STAFF REPORT

Leder Hillsboro Company Limited – Part 1
042-UP-83

SUBJECT: Delegation Request: Modify Conditions of Plat Approval
(Amendment to Non-Vehicular Access Line)
Leder Hillsboro Company Limited – Part 1 (042-UP-83)

**SKETCH & DESCRIPTION
NON-VEHICULAR ACCESS LINE**

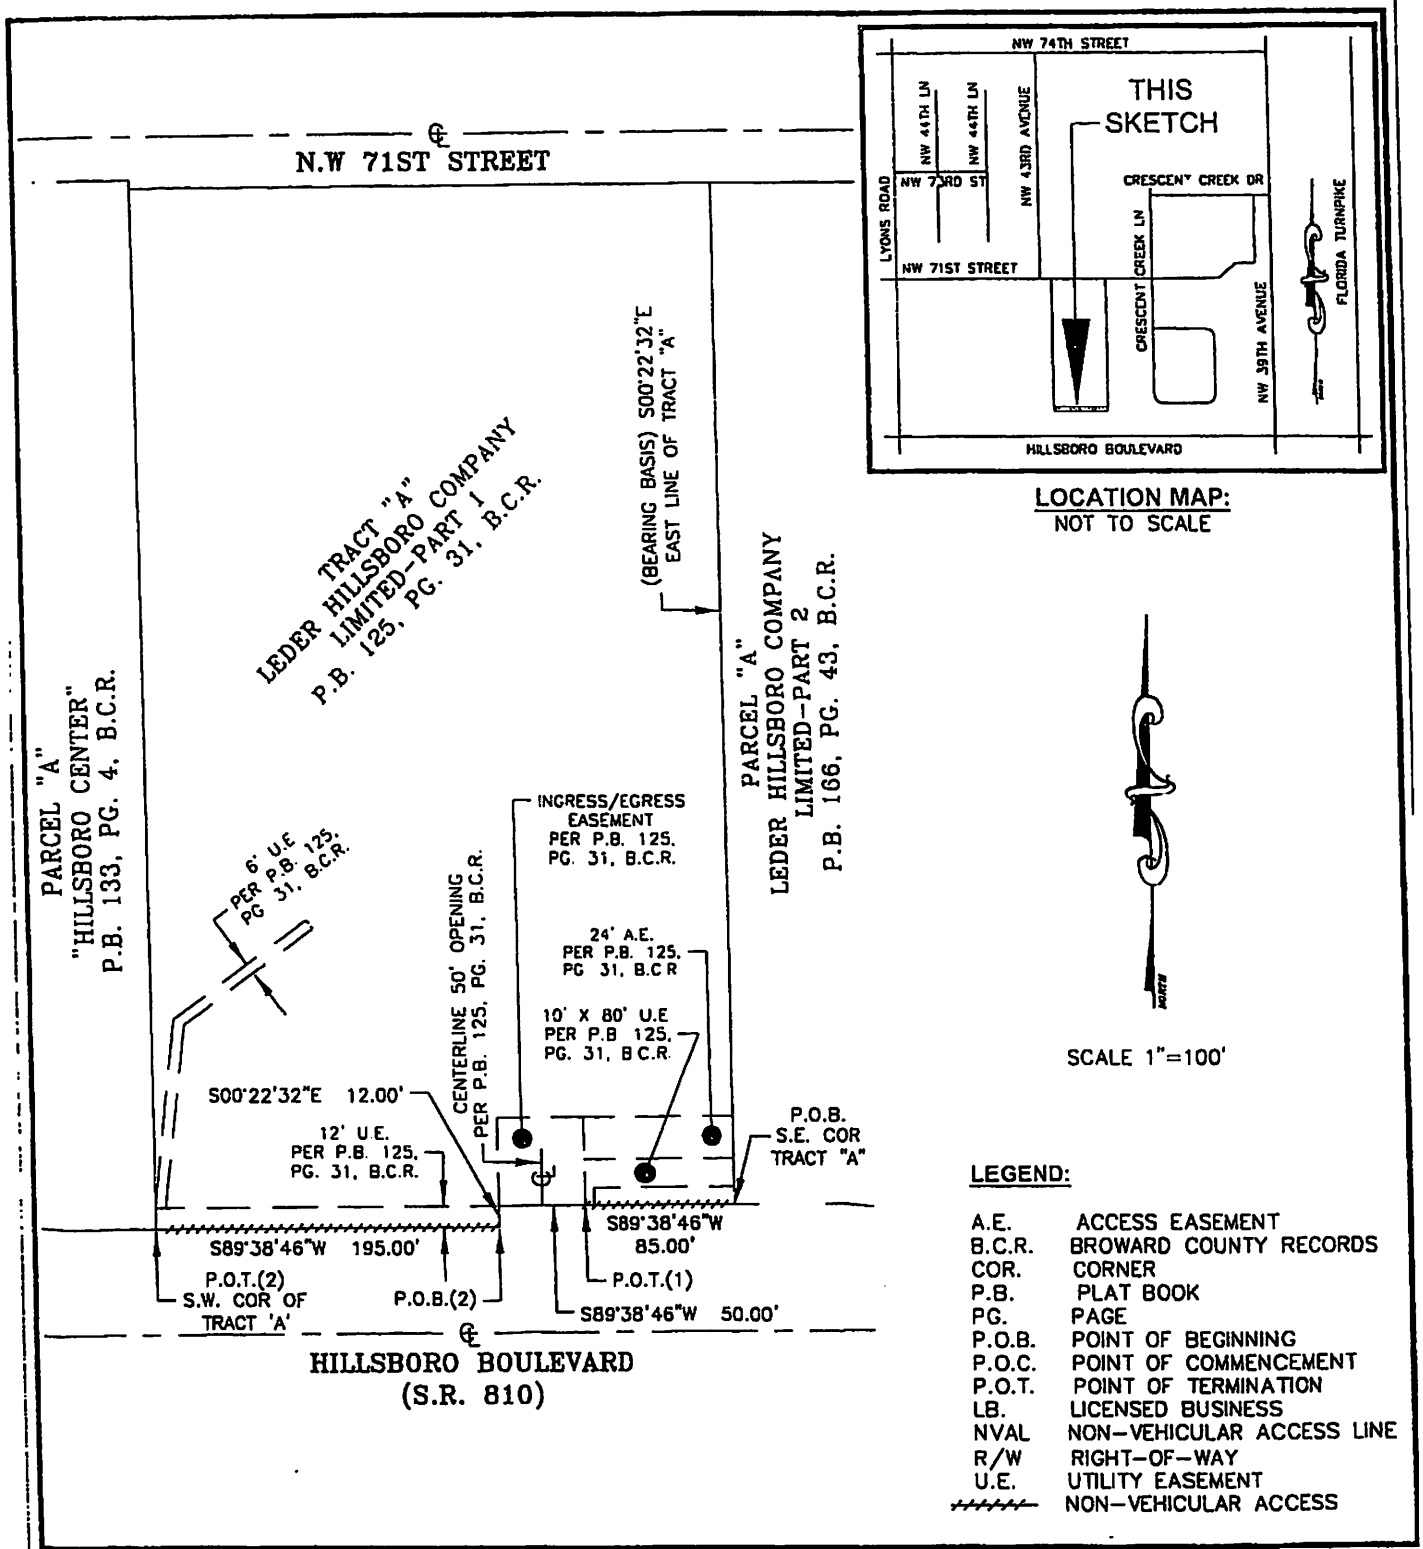
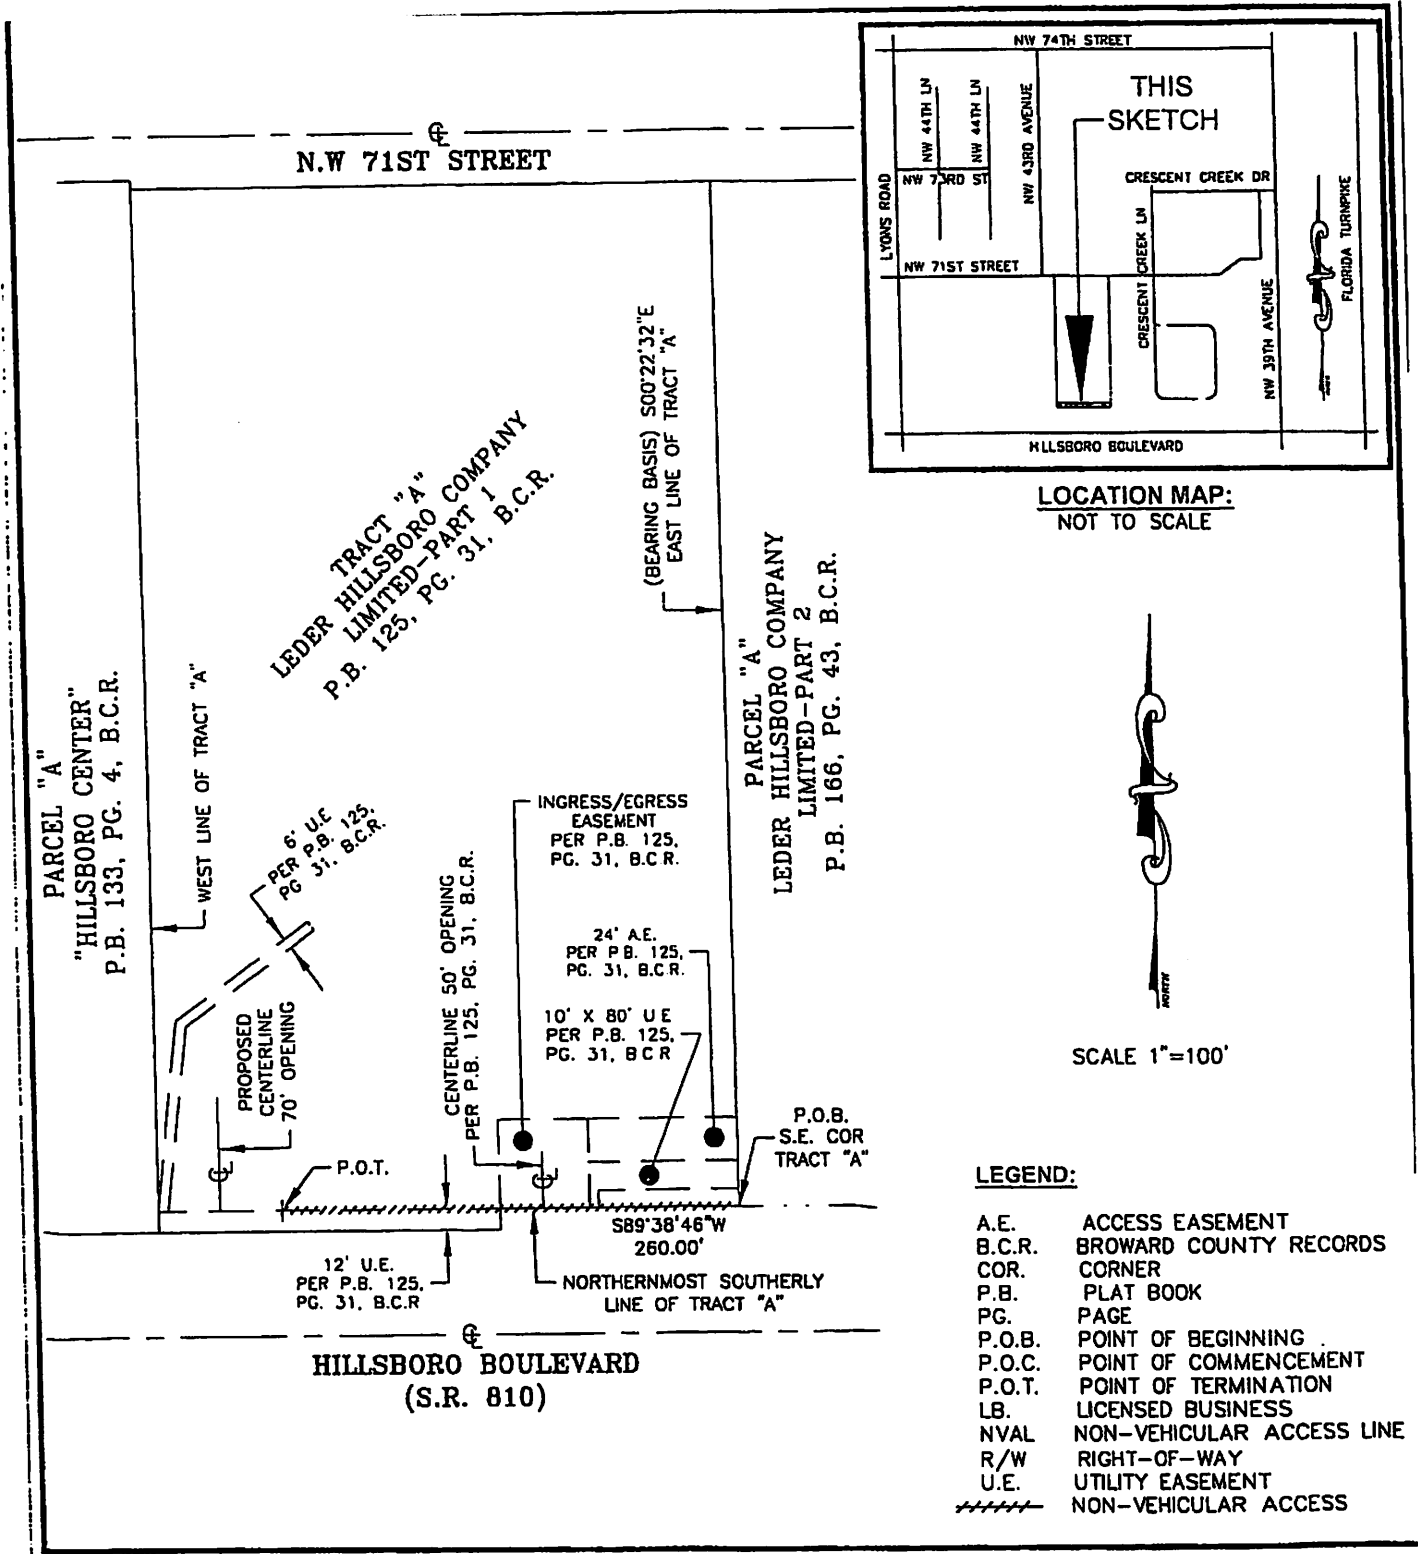
The applicant is requesting to amend the non-vehicular access line along Hillsboro Boulevard adjacent to the plat to move the access driveway to the western side of the plat and expand the driveway from 50' to 70'.

6. Exhibit "C" to the NVAL Amendment Agreement shall describe and illustrate a new non vehicular access line along Hillsboro Boulevard adjacent to the plat except at the following openings:

- a. A 70-foot opening centered 35 feet east of the west plat limits. This opening shall be labeled on Exhibit C: RIGHT TURNS ONLY.

7. For the two-way driveway that will be centered in a 70-foot opening: the minimum pavement width shall be 24 feet, the minimum entrance radii shall be 30 feet.

8. A 24-foot wide access easement is required at the new 70-foot opening that connects the opening to the adjoining parcel to the east. The property owner must execute and deliver an easement that provides for cross access with the adjoining property. The property owner may use the standard "Declaration of Restrictive Covenants for Private Paved Roadway" (CAF#463) to create this type of easement. Use of a non-standard access agreement will require review and approval by the County Attorney's office.
